TRINITY CHRISTIAN ACADEMY NEW PERFORMING ARTS BLDG.

EARLY SITE & FOUNDATION PACKAGE
17001 ADDISON RD., ADDISON, TX 75001

WATER & SEWER PLAN

C3.0

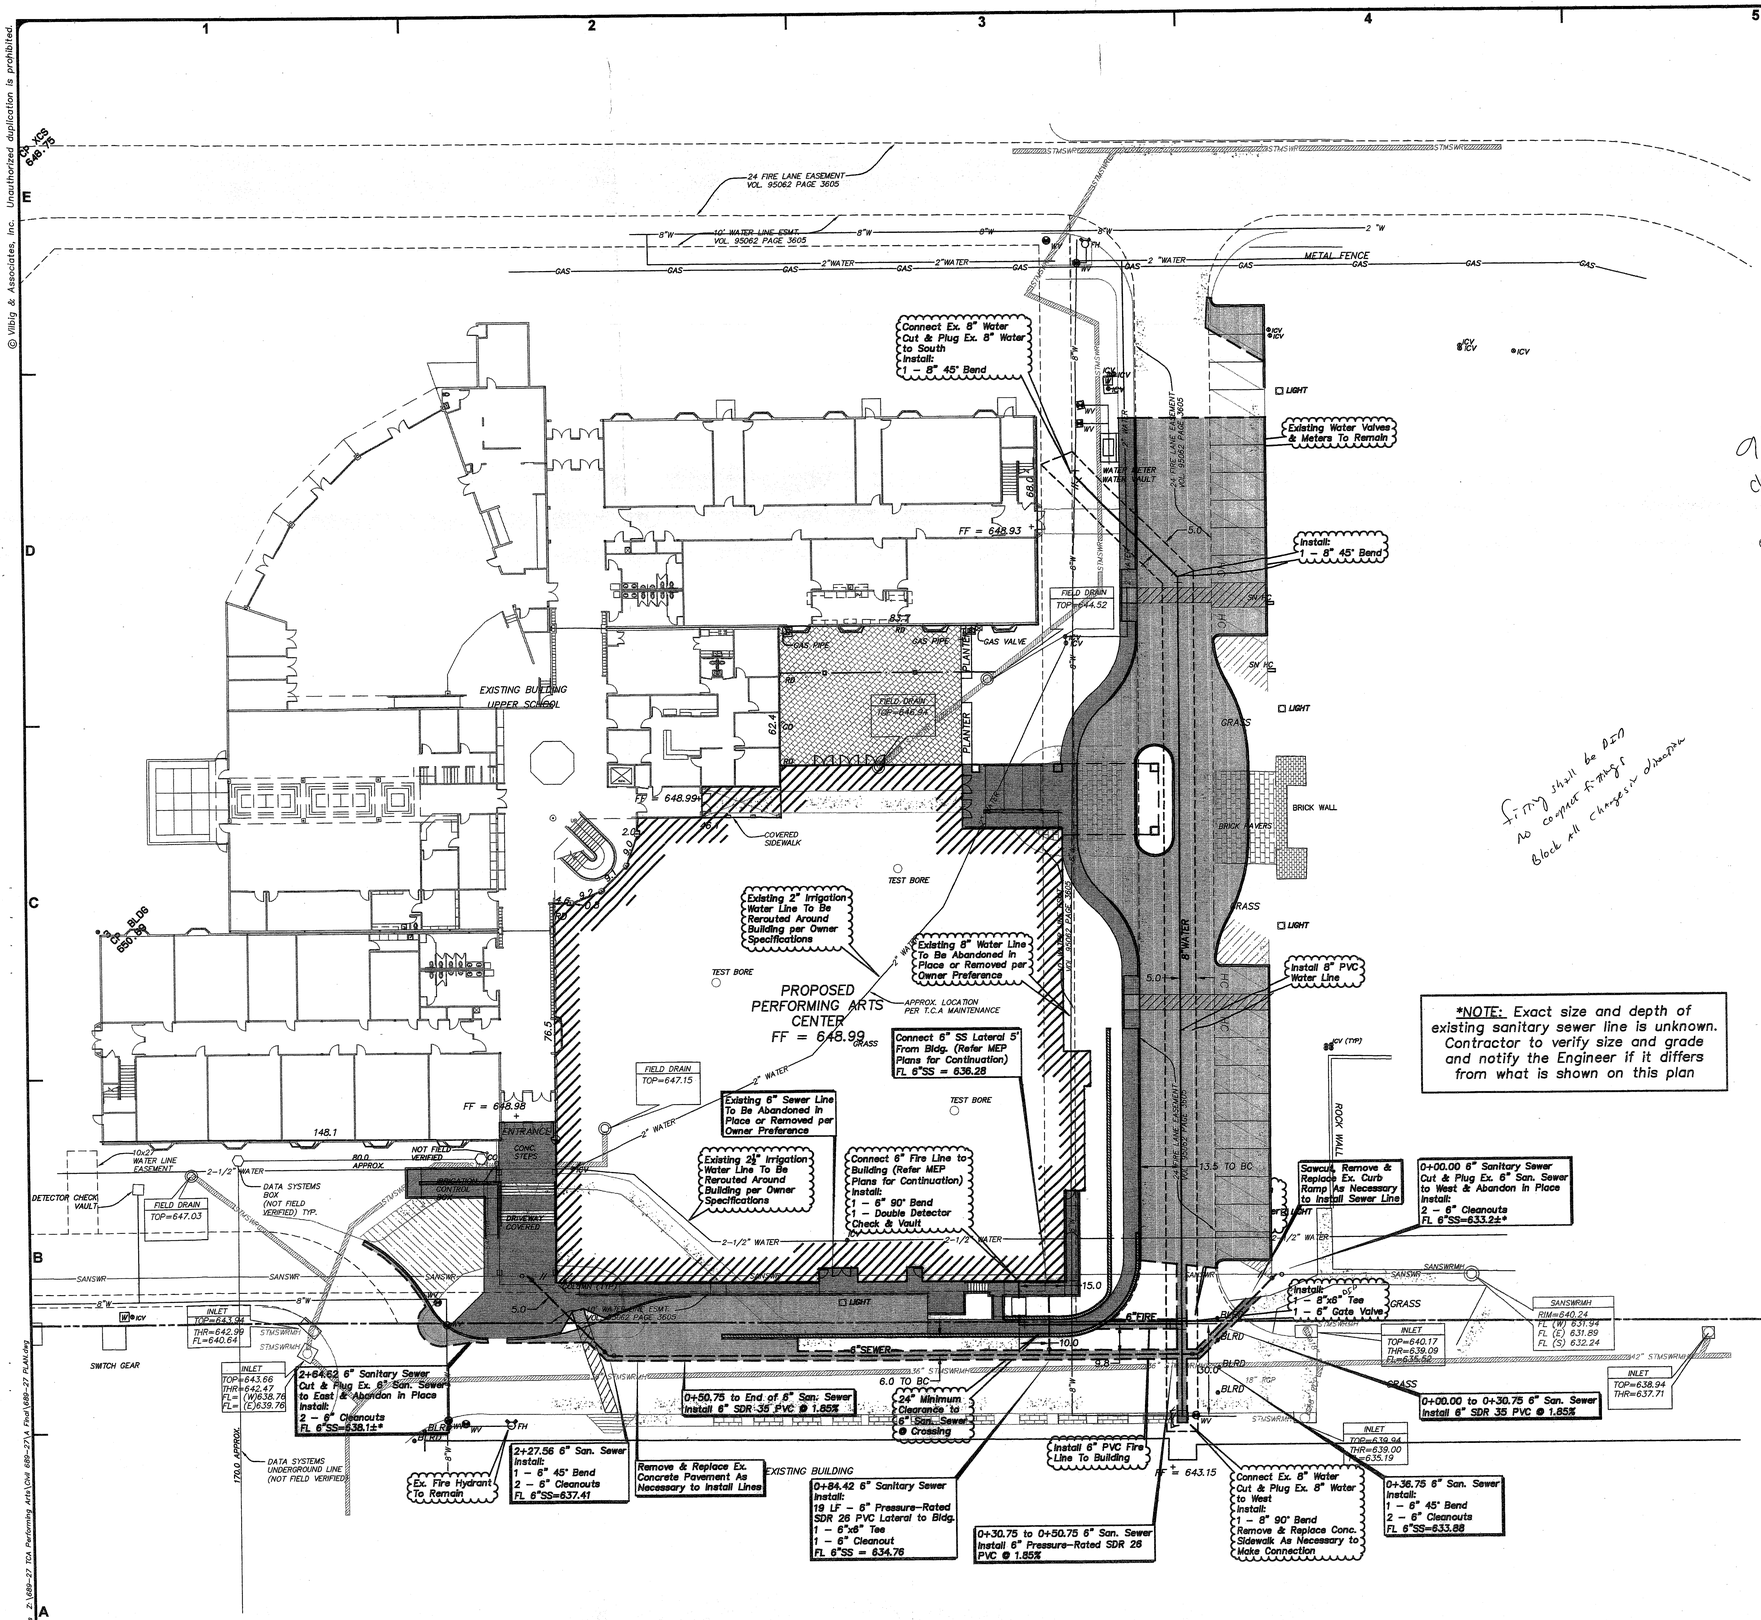
9 feet clear all joints On use pressure rated couplings cover up to

fitting shall be DIP No compact fittings Block all changes in direction
